DOCKETED	
Docket Number:	12-AFC-03
Project Title:	Redondo Beach Energy Project
TN #:	201579
Document Title:	Revised Figures 5.13-5R and DR 45-1R
Description:	N/A
Filer:	Sarah Madams
Organization:	CH2M HILL/ S. Madams
Submitter Role:	Applicant Consultant
Submission Date:	1/21/2014 10:44:17 AM
Docketed Date:	1/21/2014

Subject: Redondo Beach Energy Project (12-AFC-03)

Revised Figure 5.13-5 and Figure DR 45-1

FIGURE 5.13-5R View from Key Observation Point 4 AES Redondo Beach Energy Project Redondo Beach, California

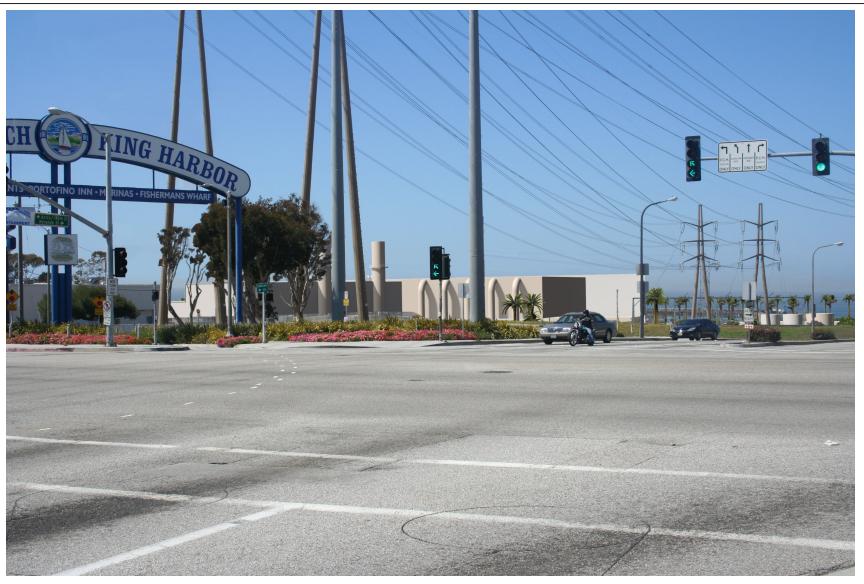
As discussed between CEC Staff Jeff Juarez and CH2M HILL technical staff Joshua Hohn on January 15, 2014, it has come to the Applicant's attention that Figure 5.13-5 (from the Application for Certification) and Figure DR 45-1 (from Data Response Set 1A submitted on November 12, 2012), are missing portions of the existing 230kV switchyard that will remain at the Redondo Beach Energy Project (RBEP). As requested by Mr. Juarez, the figures have been updated to include the added switchyard equipment. Attached please find the revised figures provided as Figure 5.13-5R and Figure DR 45-1R.
